D01 Internal Engineering Handoff

Review revision IH02 | Mechanical R03M | Electrical E00 with supplements | 5 October 2026

Decision requested: review and resolve the open engineering items in REVIEW_AND_RELEASE_REGISTER.csv. This is a coordinated design-review issue, not a fabrication or energization issue. Manufacturer replies are not the only remaining dependency.

Fabrication: two joined guard assemblies

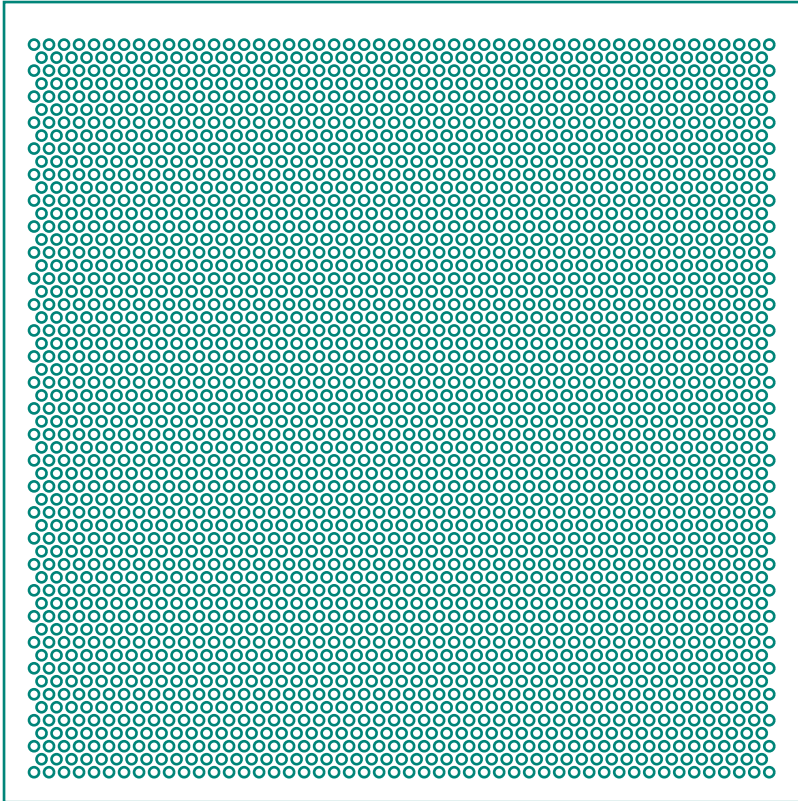
PROPOSED route: fabricated steel guards with joined face, four corner seams and welded mounting-angle laps. This replaces loose sheets/rivets; independent guard-to-plate bolts remain.

W1 joins the face perimeter. W2 joins four vertical corners. W3 joins each mounting-angle lap along its two short edges and top edge. These define joint locations, NOT a released weld size/process. Thin-sheet distortion, toe clearance and capacity require qualified fabrication review.

Proposed face pattern: 2822 holes,4 mm diameter,6 mm staggered pitch, at least10 mm solid border. Exact hole area 0.03546 m2 each.2D DXF supplied;3D face still an envelope. No finger-access approval.

No old rivet holes in the new blanks. Deburr all cut edges; no sharp projections or weld spatter near filters/fans. Material grade/coating and welding procedure are not yet selected.

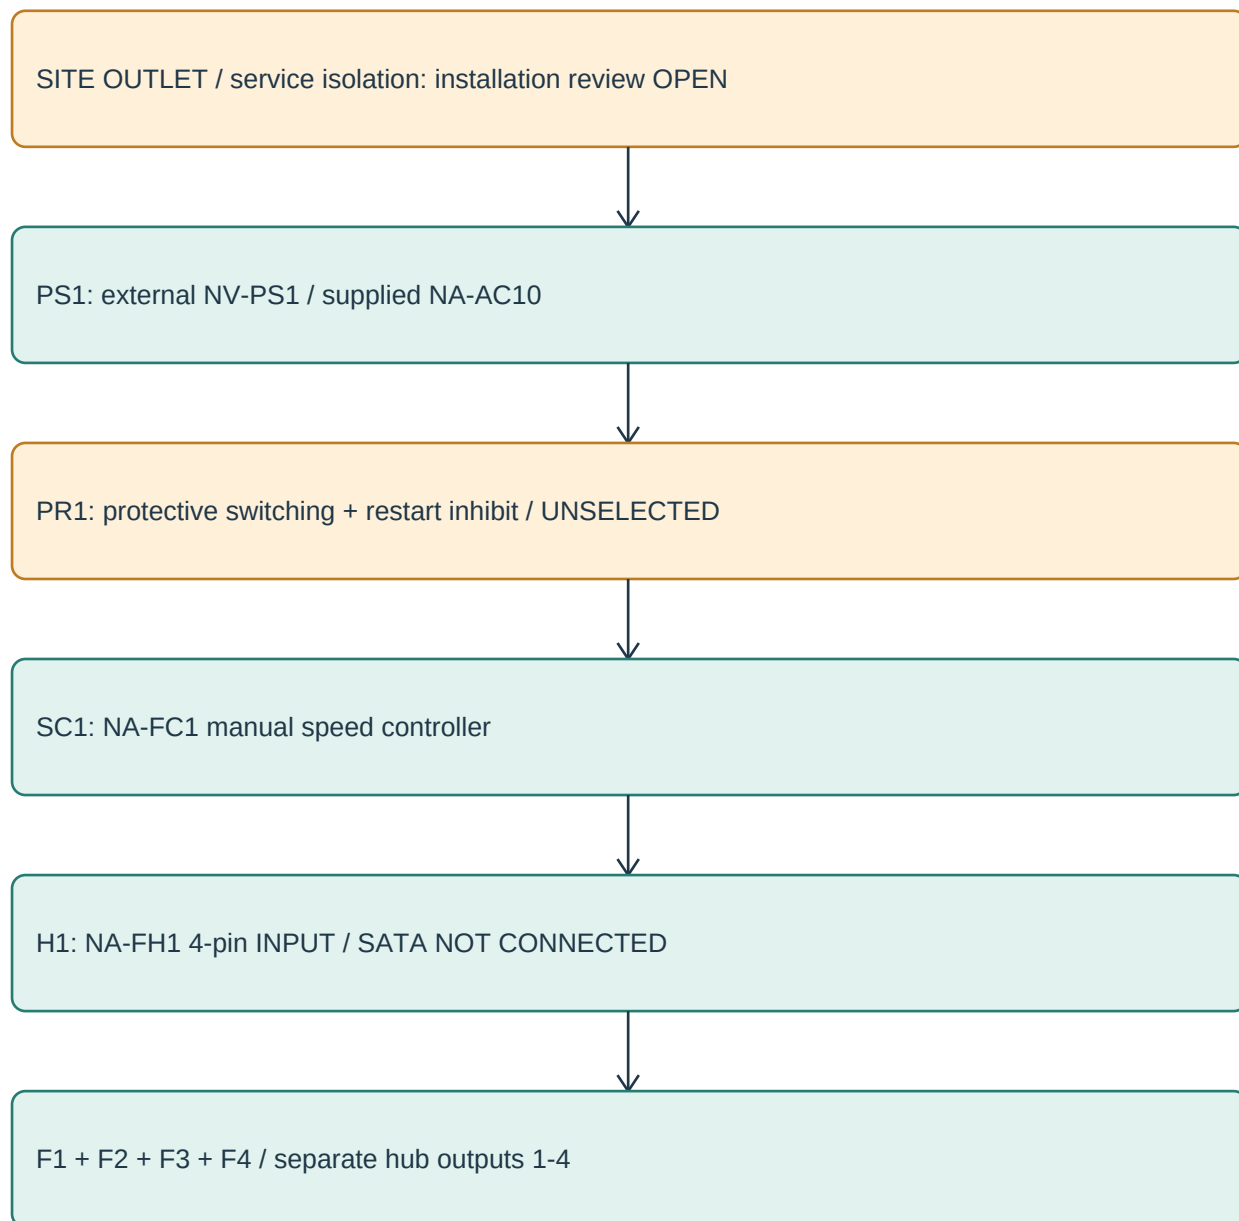
DETECTED: four fans total 1.40 A / 16.8 W nominal. The adapter and selected hub input are limited to 2 A / 24 W. The difference is 0.60 A before controller/hub consumption, startup and tolerances; it is not proven spare capacity.

RECOMMENDATION: retain the external adapter, fixed guards and separate protective module approach. Do not add a 24 V safety relay merely to fill a BOM: a separate control supply can remain alive while the 12 V supply trips and recovers.
